**DOCKET 50-255 - LICENSE DPR-20 - PALISADES NUCLEAR PLANT
SUPPLEMENTAL INFORMATION TO TECHNICAL SPECIFICATION CHANGE
REQUEST - SPENT FUEL POOL BORON CONCENTRATION**

TECHNICAL SPECIFICATION CHANGE REQUEST
SPENT FUEL POOL BORON CONCENTRATION
SUPPLEMENT

**SUPPLEMENTAL INFORMATION TO TECHNICAL SPECIFICATION CHANGE
REQUEST - SPENT FUEL POOL BORON CONCENTRATION**

**PAGE CORRECTIONS TO THE MARCH 2, 2001
TECHNICAL SPECIFICATION CHANGE REQUEST**

Figure B 3.7.16-1 (page 1 of 1)
Spent Fuel Pool Arrangement

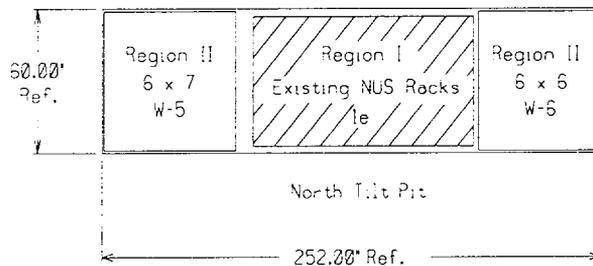
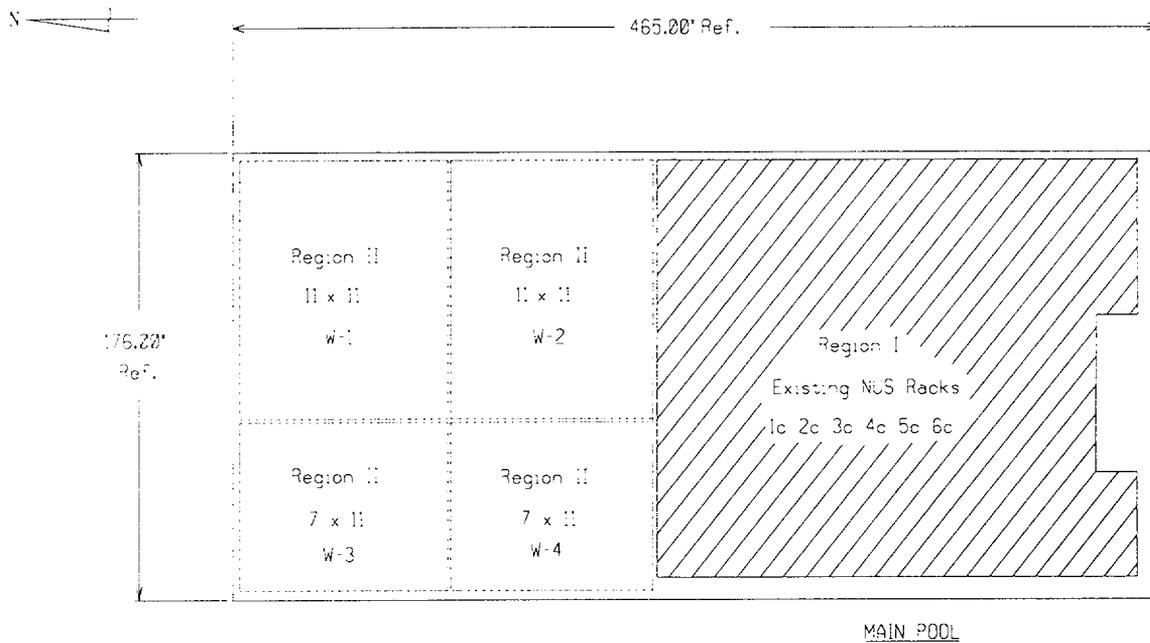
By letter dated March 2, 2001, Nuclear Management Company, LLC (NMC) submitted the subject Technical Specification Change Request (TSCR). The NRC staff requested supplemental information to facilitate their review during telephone conversations with Palisades staff members on September 12, 2001, and December 4, 2001. Attachment 1 provides this supplemental information. In addition, Attachment 2 provides page corrections to five pages contained in the March 2, 2001, TSCR. These page corrections address typographical errors and provide a more legible figure containing the Palisades spent fuel pool configuration.

4.3.1.2 The Region II fuel storage racks (See Figure B 3.7.16-1) are designed and shall be maintained with;
